1968 Corvette: Service Bulletin: Gas Line Rattle

Source: Chevrolet Dealer Service Information Bulletin - General Motors Canada

Bulletin No: 68-IC-54

Date: June 29, 1968

Fig. 1.

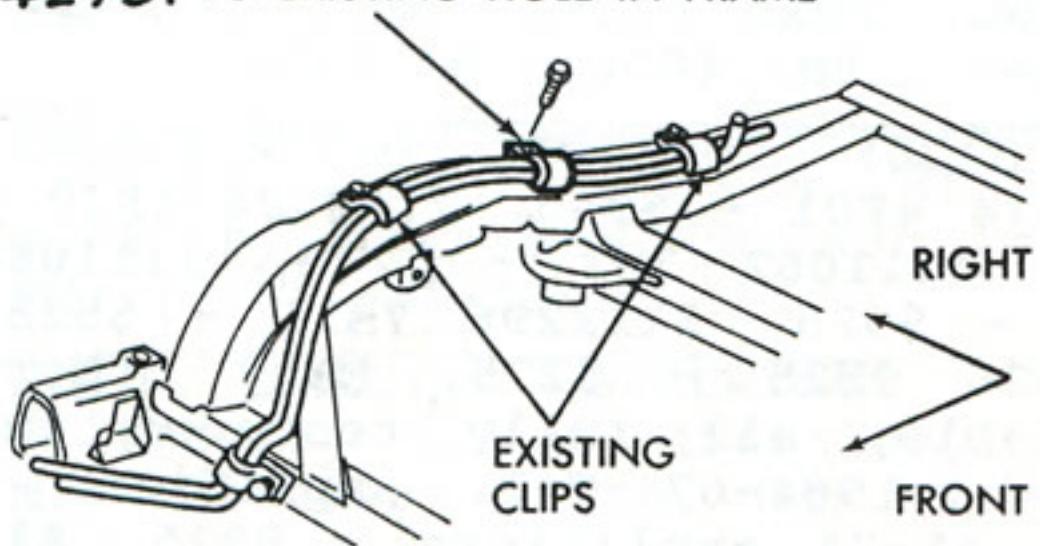
A rattling or "ticking" noise from the rear of the vehicle has been experienced on some 1968 Corvettes. This noise is resulting from the fuel supply line vibrating against the return line. Production has corrected this condition by installing an additional clip in the existing frame hole at this location. Refer to Fig. 1. This same correction is recommended for units in the Field that are experiencing the rattling or "ticking" noise. Fig. 1 illustrates where the clip should be added and gives the related parts data.

*ATTACH CLIP (3923695) WITH SCREW
442751 TO EXISTING HOLE IN FRAME
